CITY OF TONTITOWN PLANNING OFFICE

201 E. Henri de Tonti Blvd. 479-361-2700 planning@tontitownar.gov Meeting: June 27, 2021
Project: Hickory Meadows Ph 1
Final Plat

FINAL SUBDIVISION PLAT APPROVAL REQUEST

FINAL PLAT FOR HICKORY MEADOWS SUBDIVISION PHASE 1 TONTITOWN, ARKANSAS

FIGURE 2: FINAL PLAT

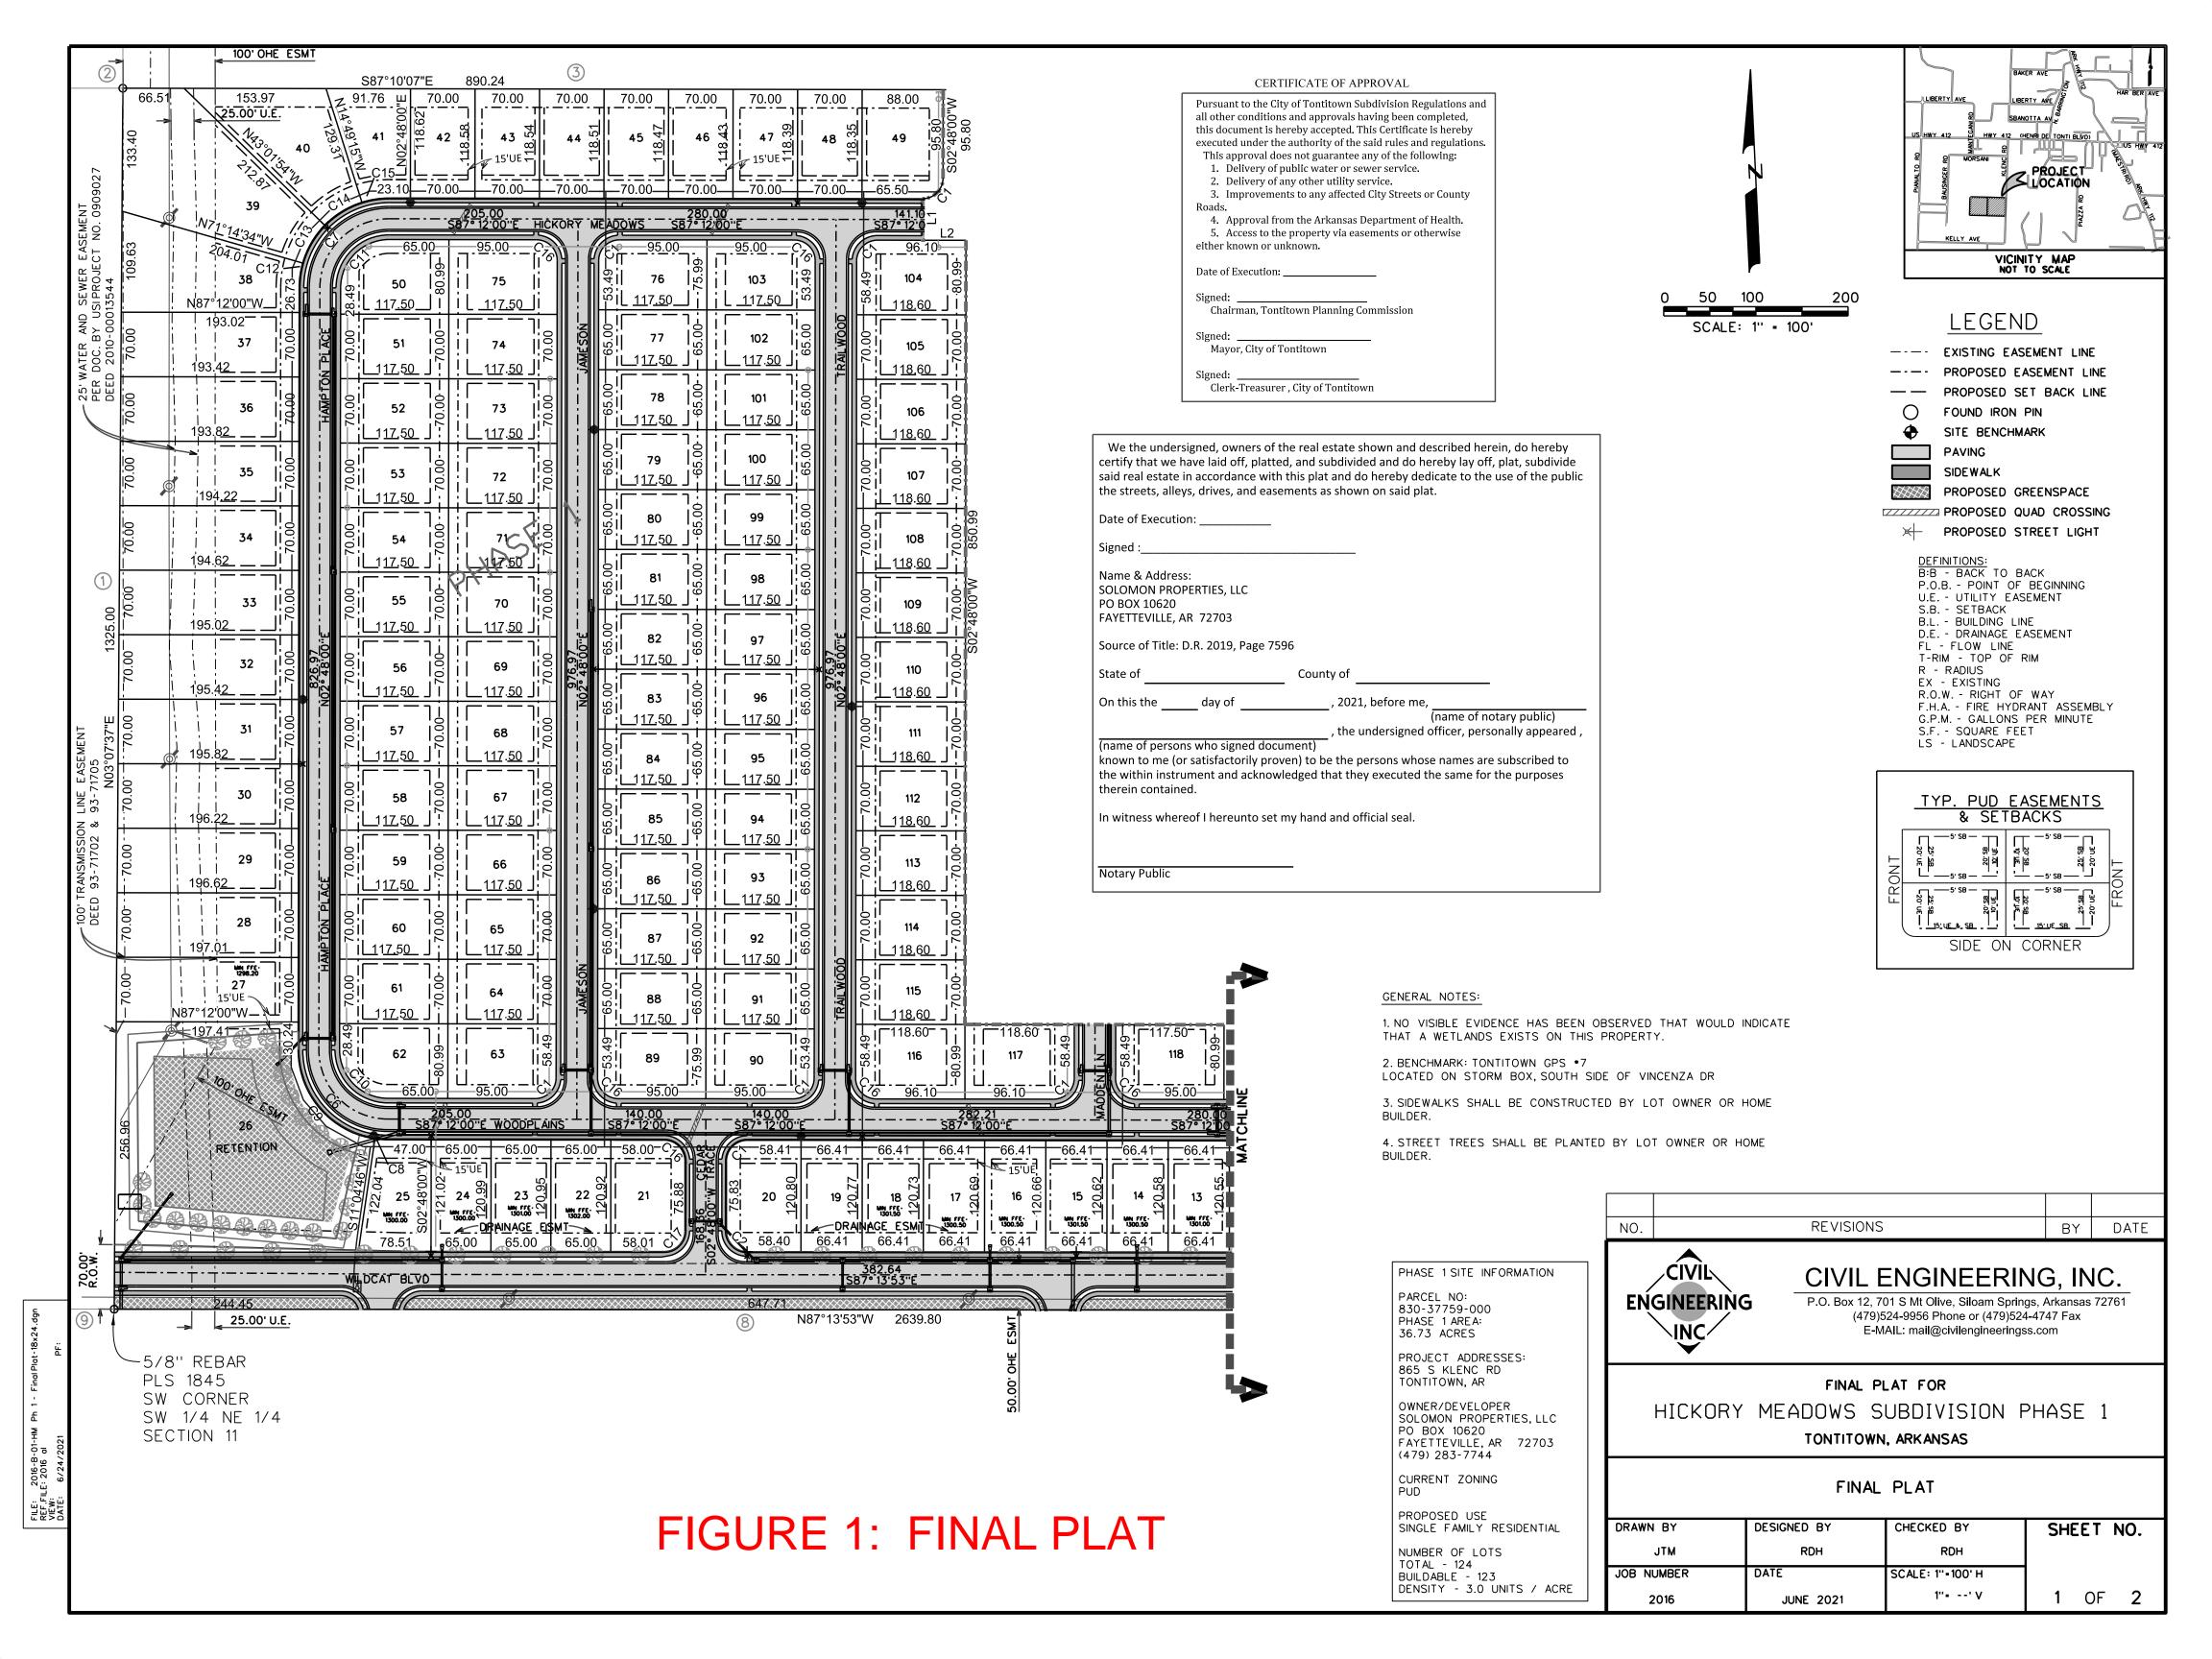
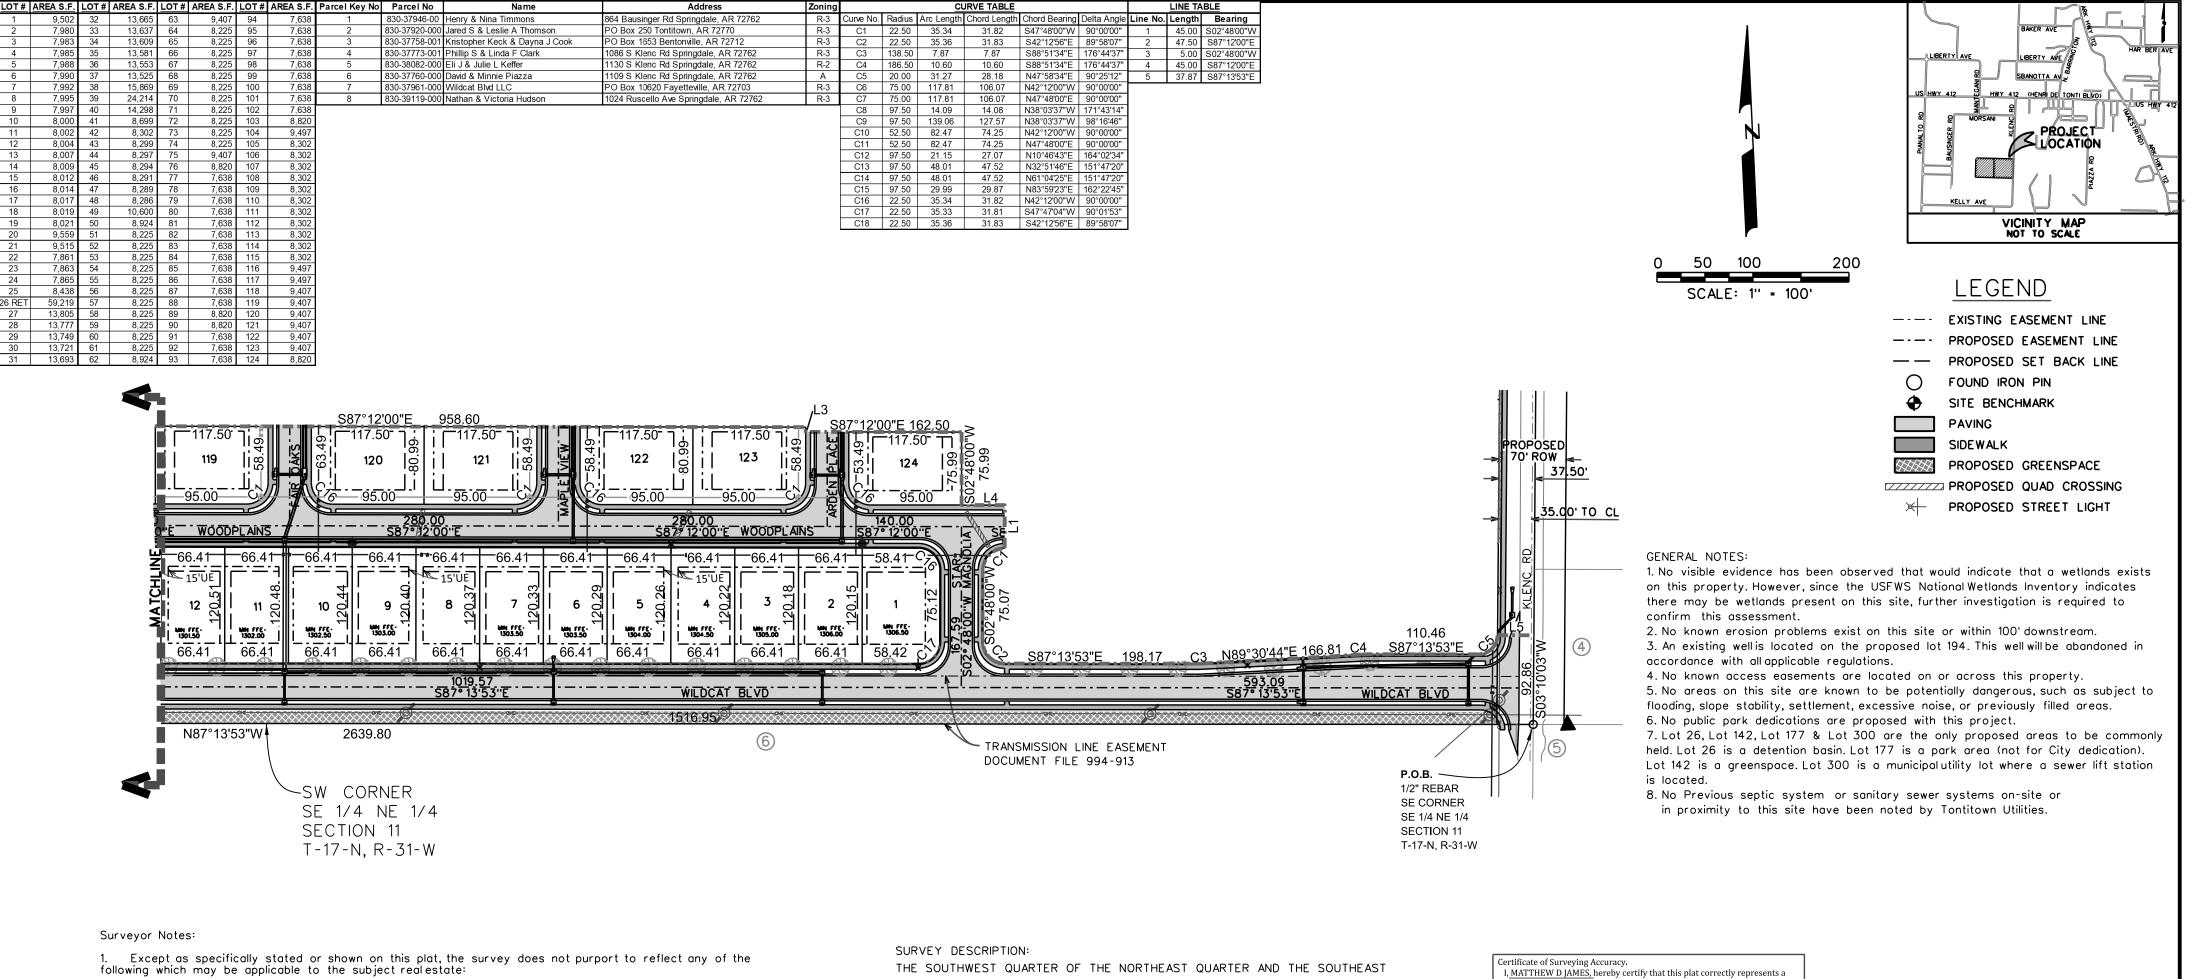
There is one outstanding checklist item that must be addressed.

1. All street testing reports will need to be sent to the City for review.

1. All street testing reports will need to be sent to the City for review.
